ADDENDUM 2

TO: All Prospective Bidders
PROJECT NO: 16822000
PROJECT NAME: Iowa Workforce Development – 2nd & 3rd Floor Remodel
CLIENT NAME: State of Iowa / DAS
PROJECT LOCATION: Des Moines, IA
DATE: 5/12/2017
CONTACT: Joe Wallace, AIA

1 LEVEL 2 FURNITURE PLAN - EAST
1/8" = 1'-0"

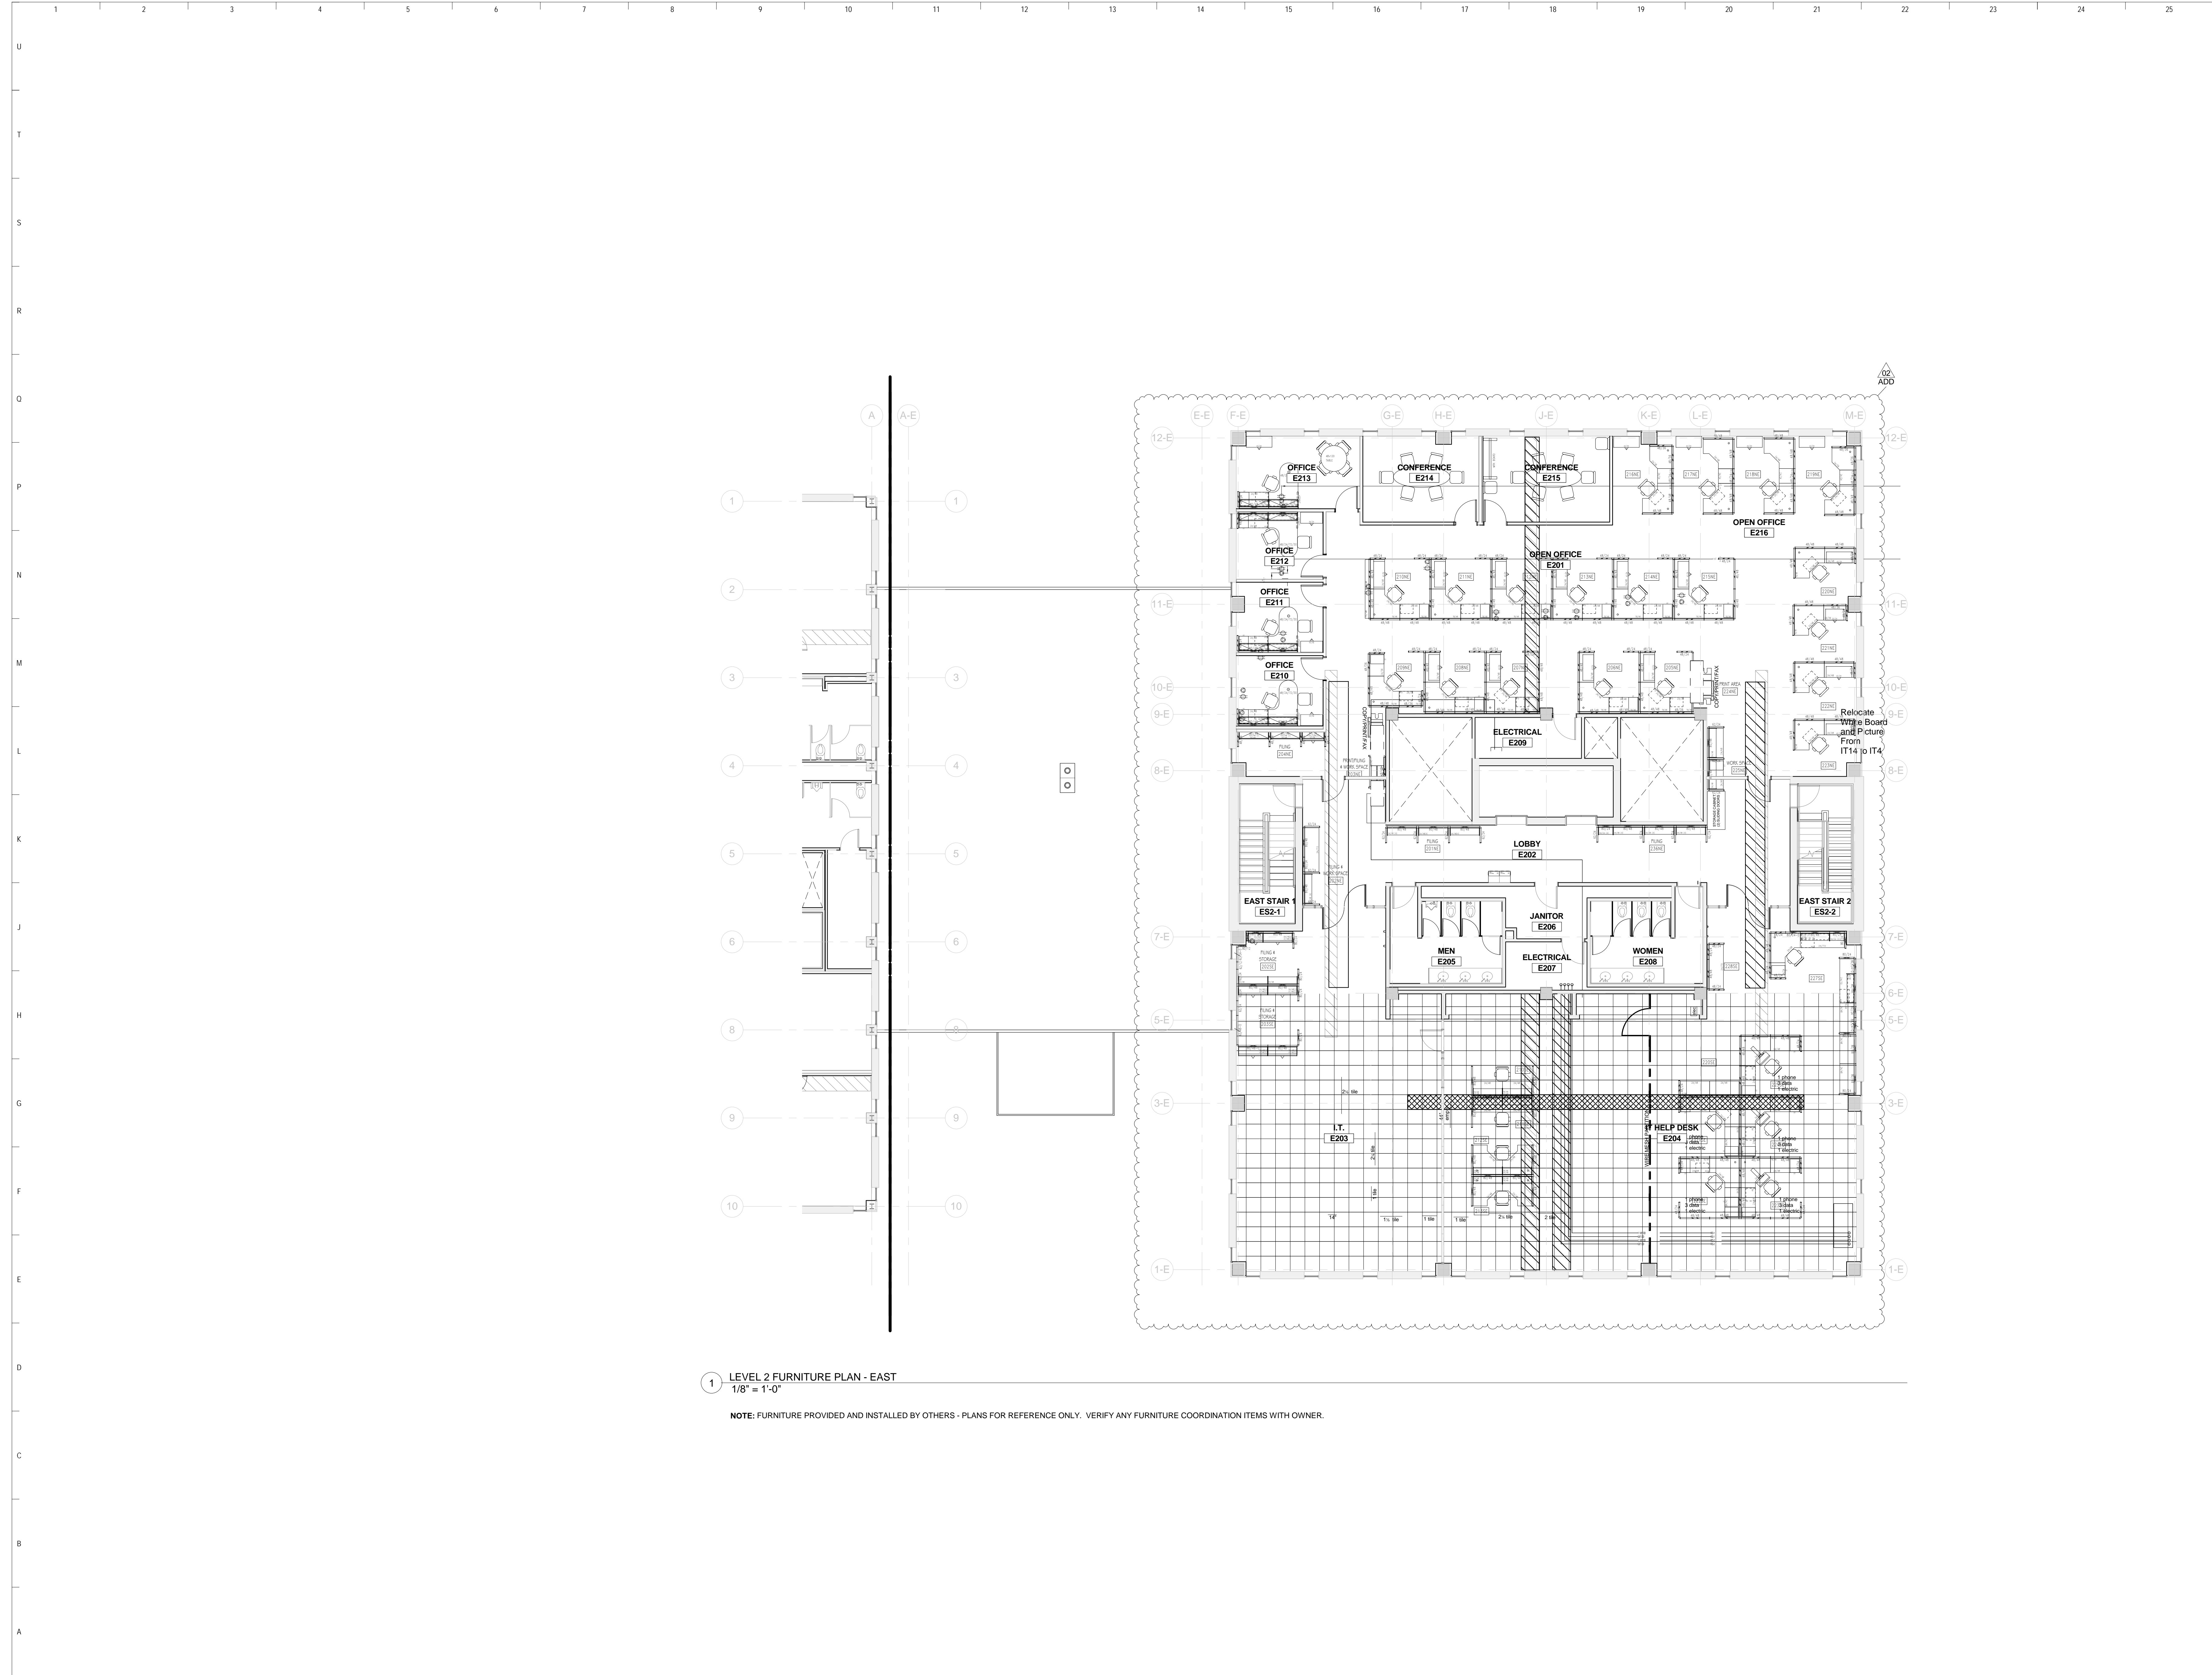
4.10 A522E – FURNITURE PLAN LEVEL 2 - EAST

- a. Revise Room Numbering on Sheet as shown.
- b. Note the intent of the Furniture plans, A522E through A523W, is for reference of the proposed furniture layouts only. Furniture systems are provided and installed by others. Verify any furniture coordination items with owner.

A522W

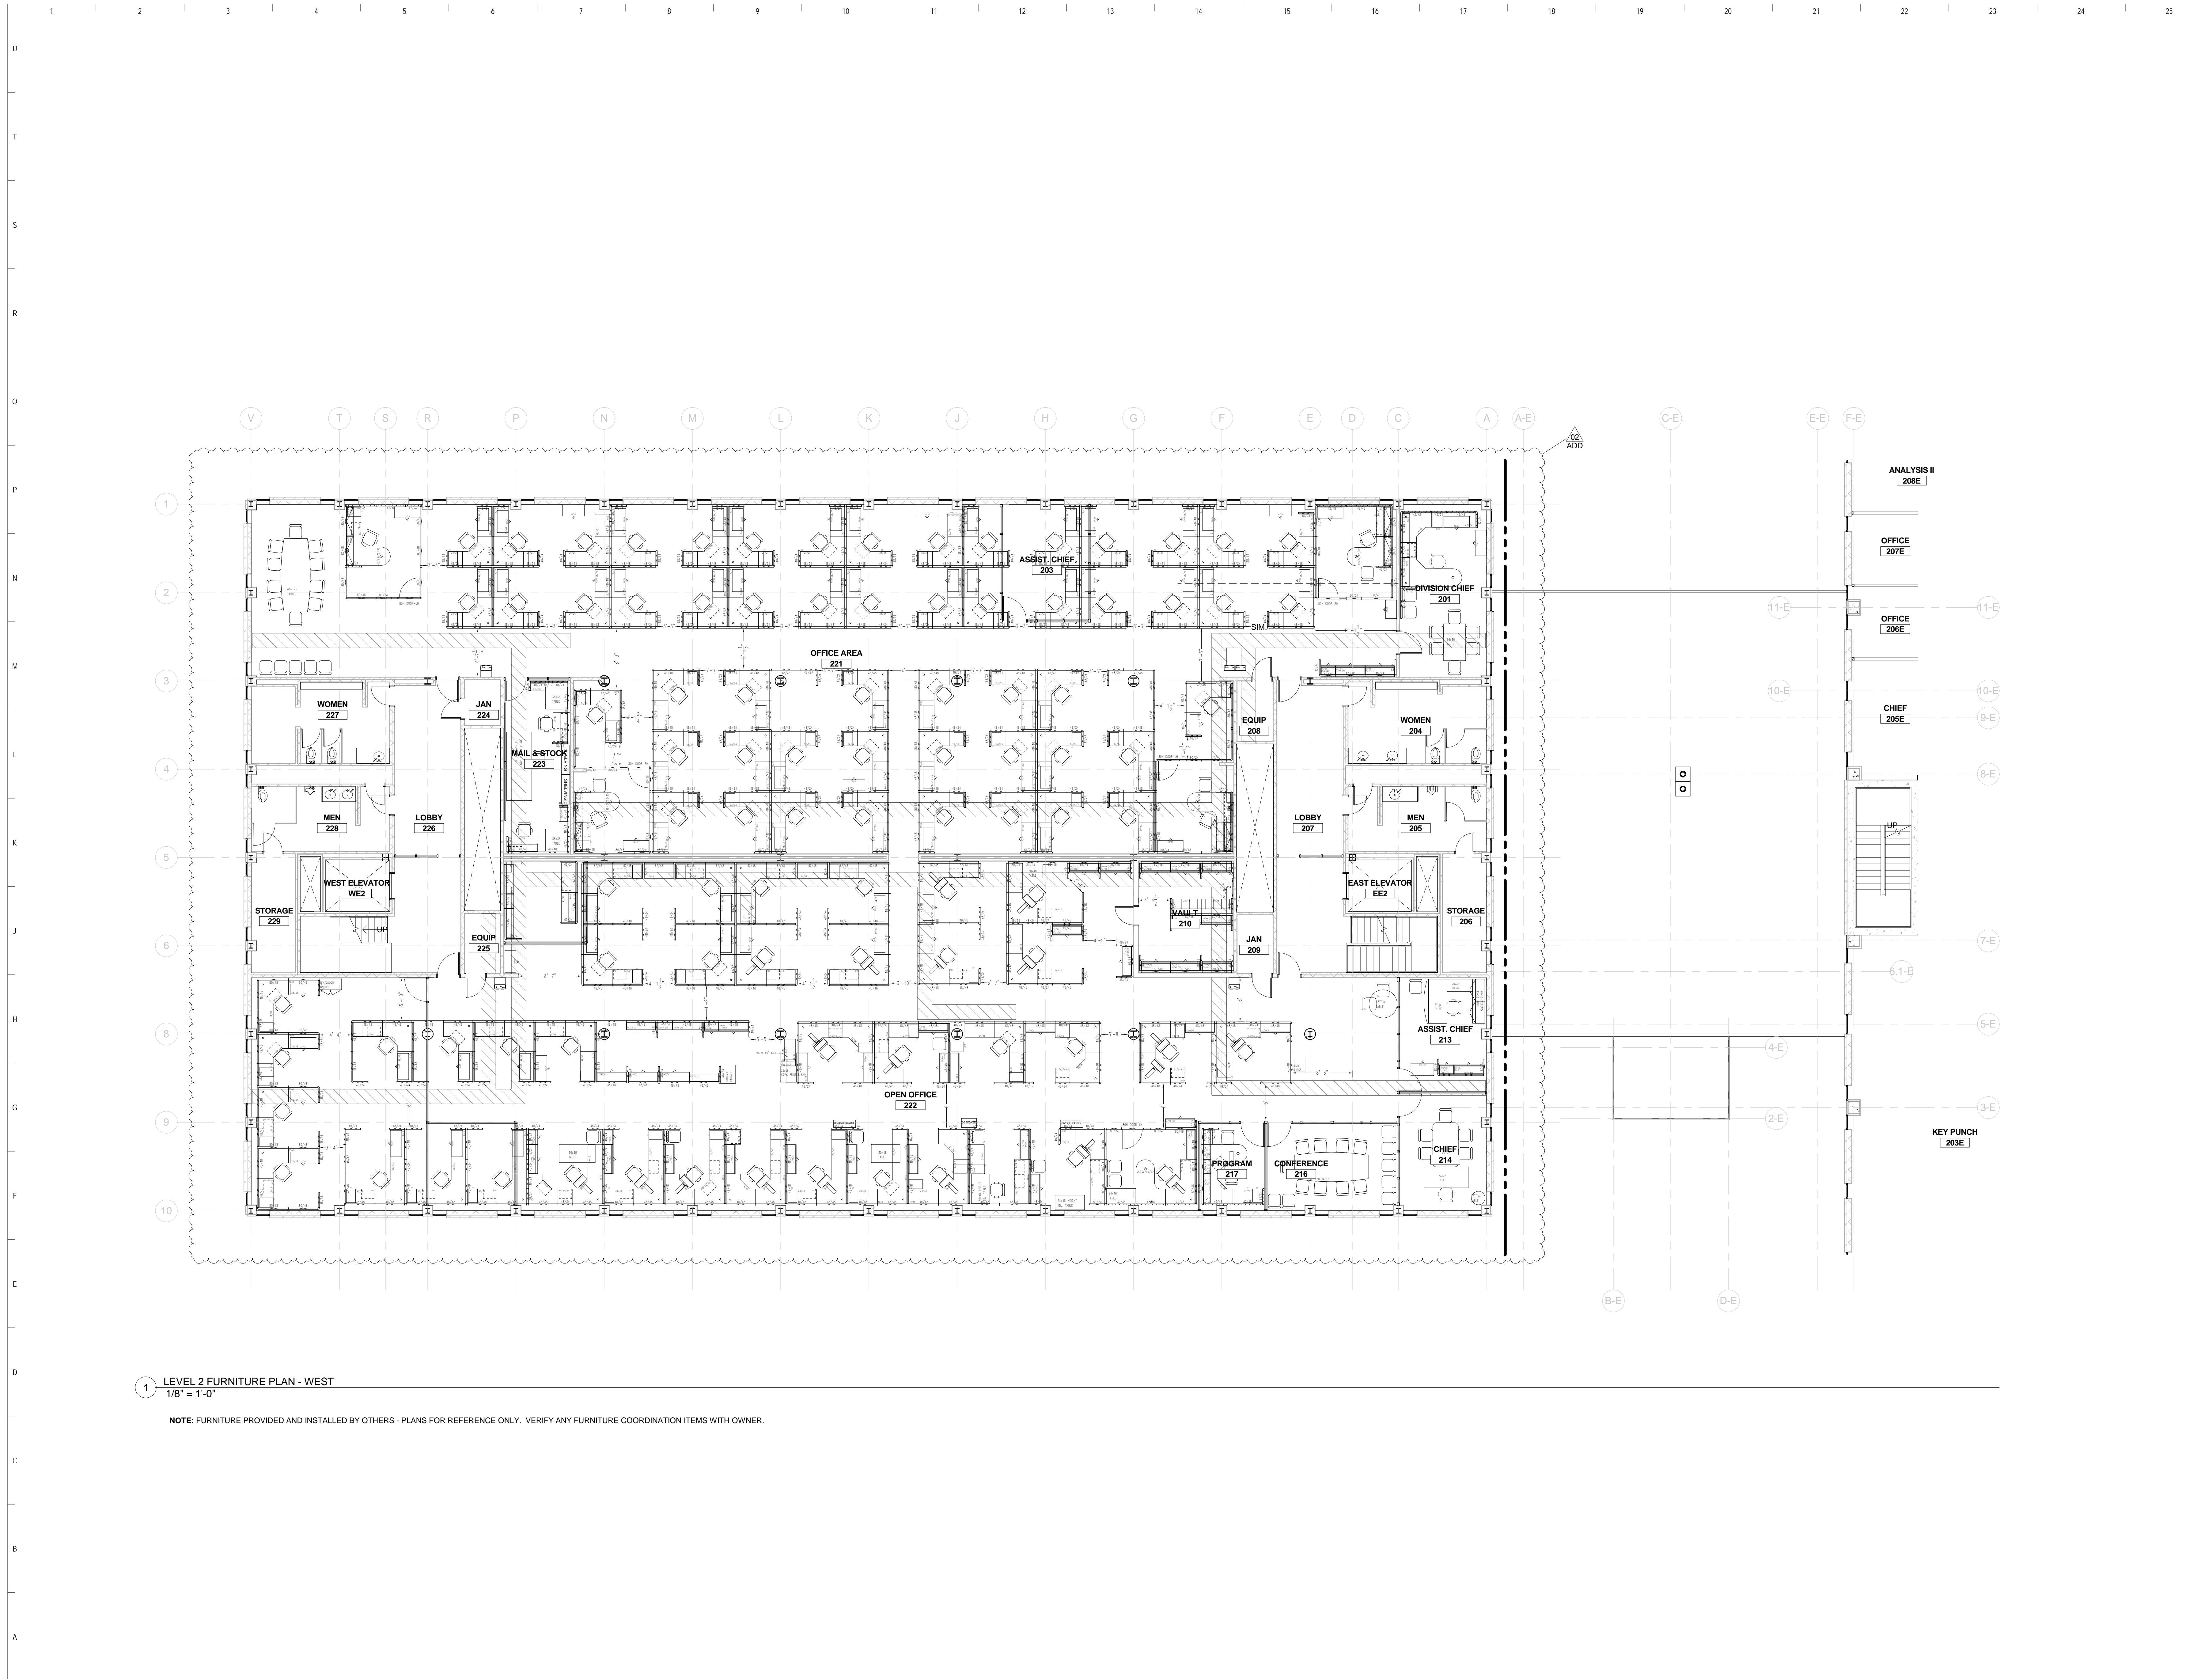
4.11 A522W – FURNITURE PLAN LEVEL 2 - WEST

- a. Revise Room Numbering on Sheet as shown.
- b. See Item 3.6.b

A523W

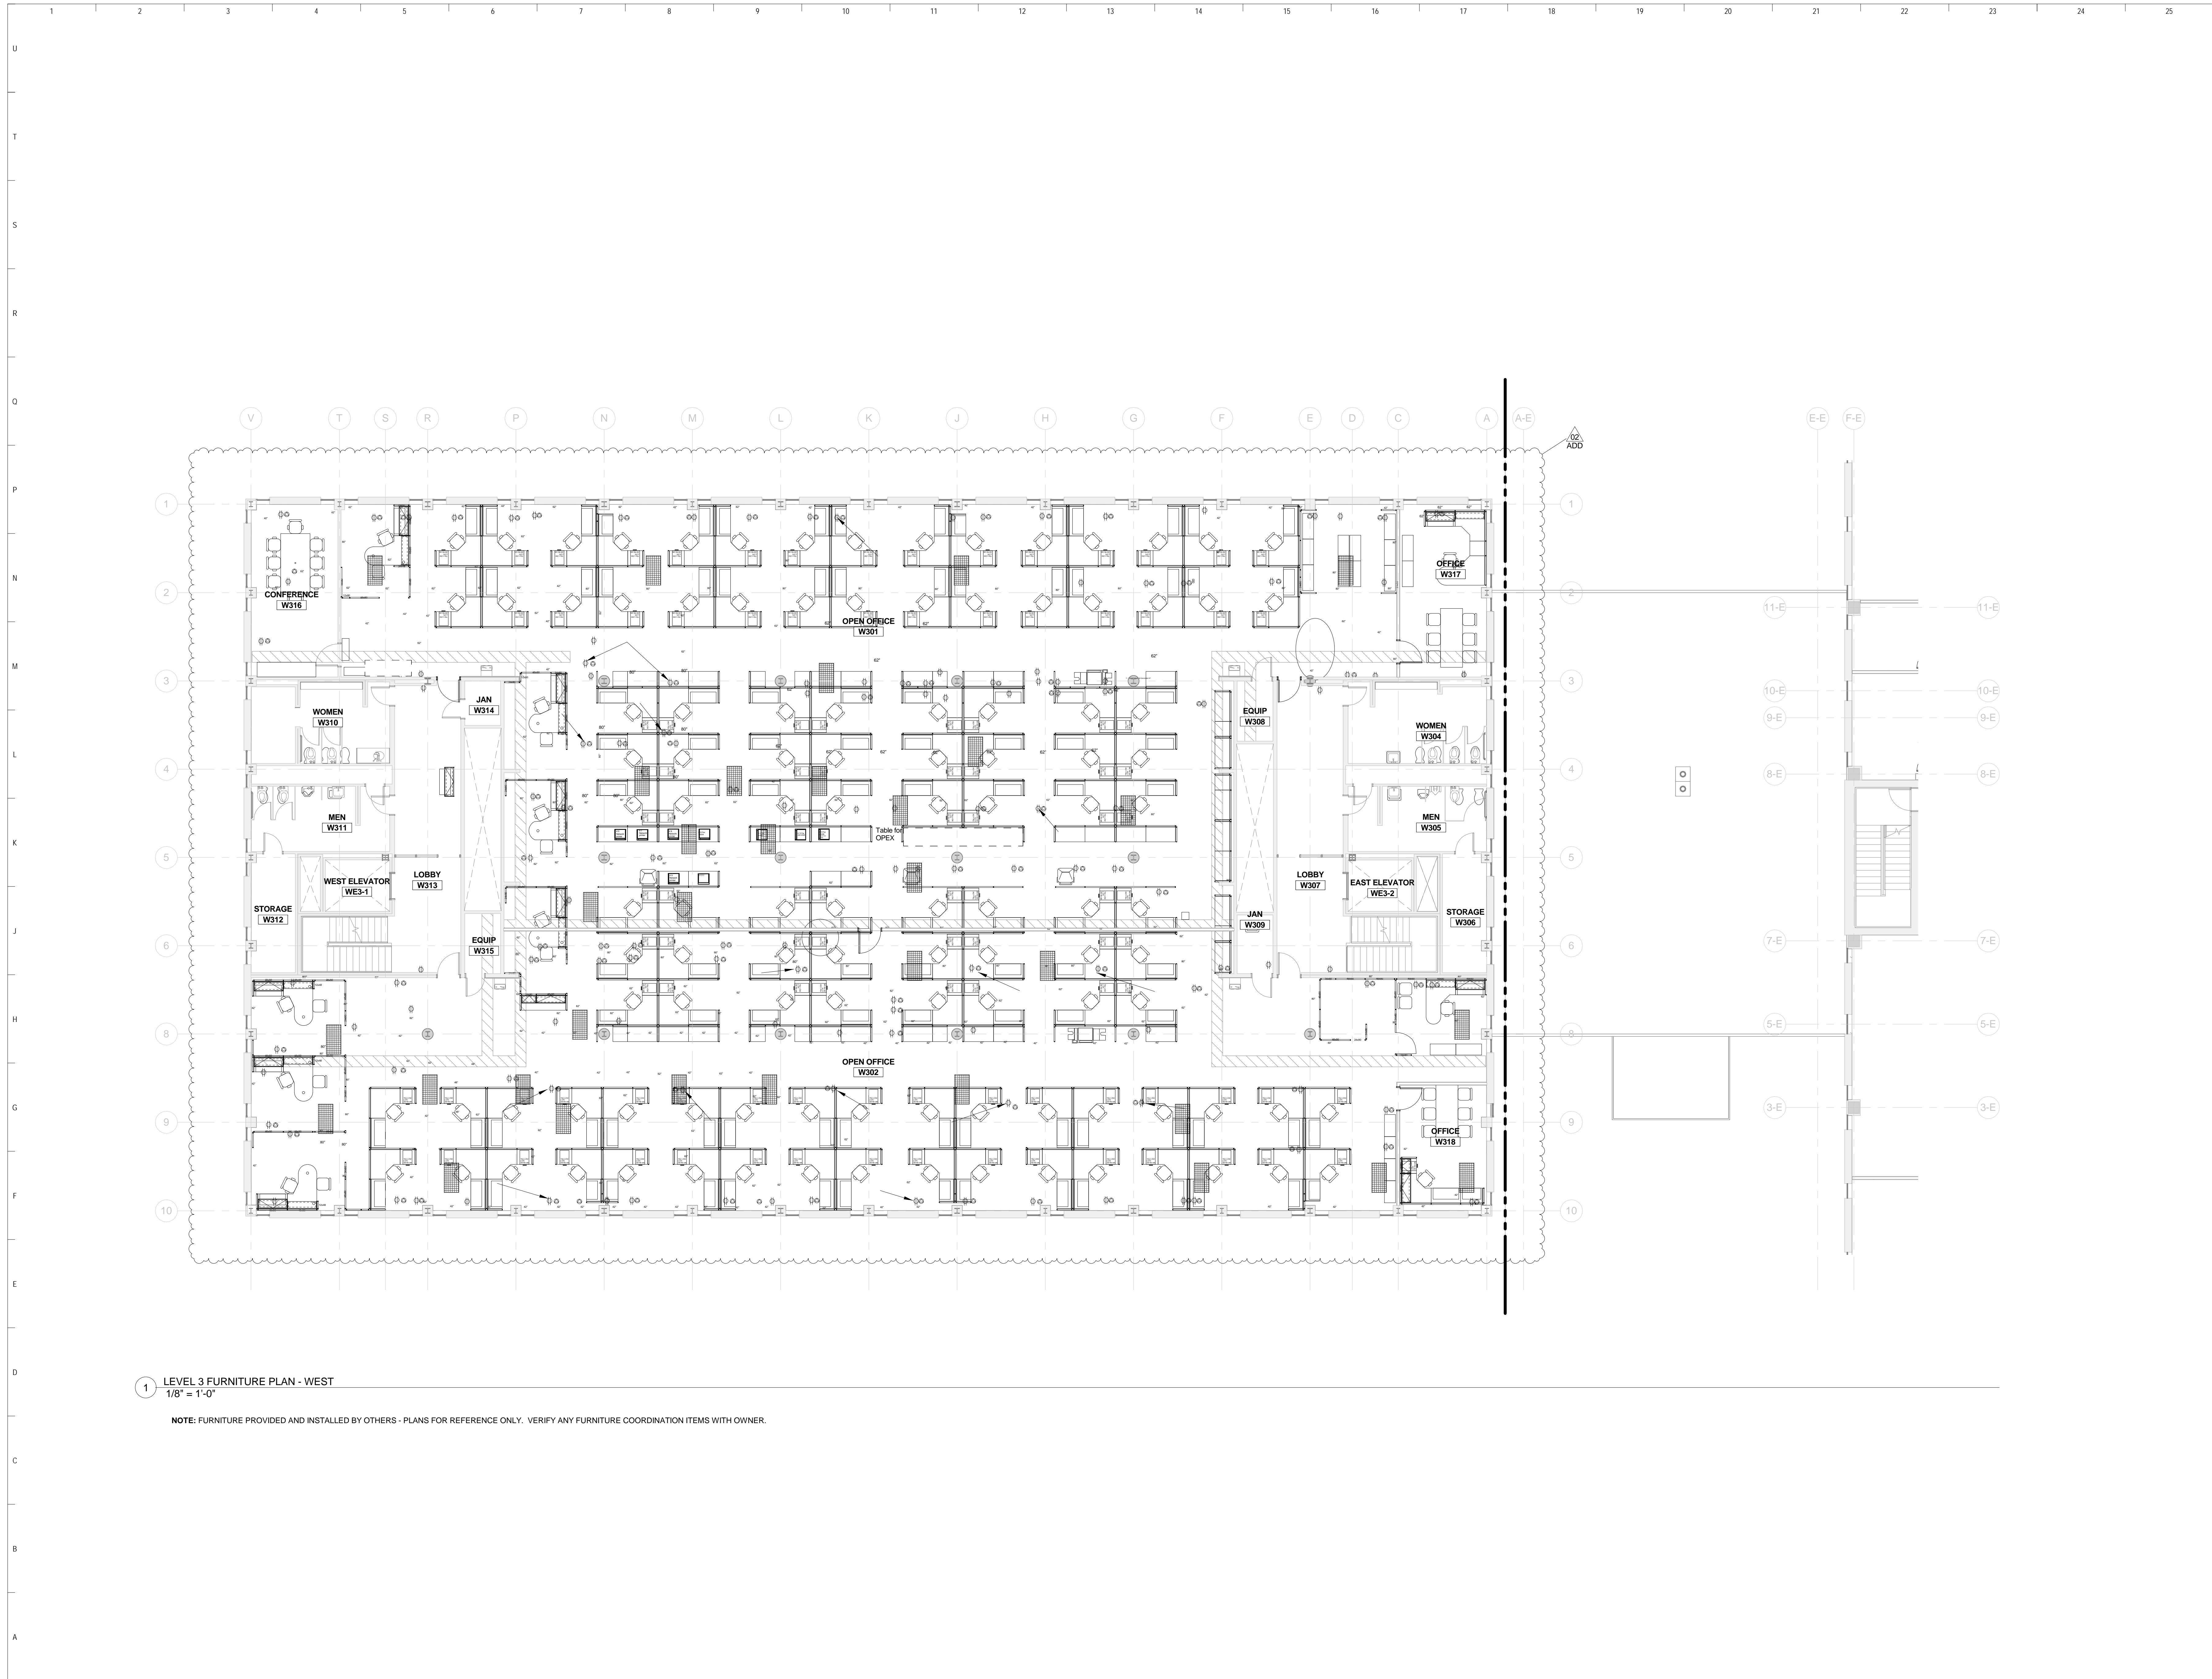
4.13 A523W – FURNITURE PLAN LEVEL 3 - WEST

- a. Revise Room Numbering on Sheet as shown.
- b. See Item 3.6.b
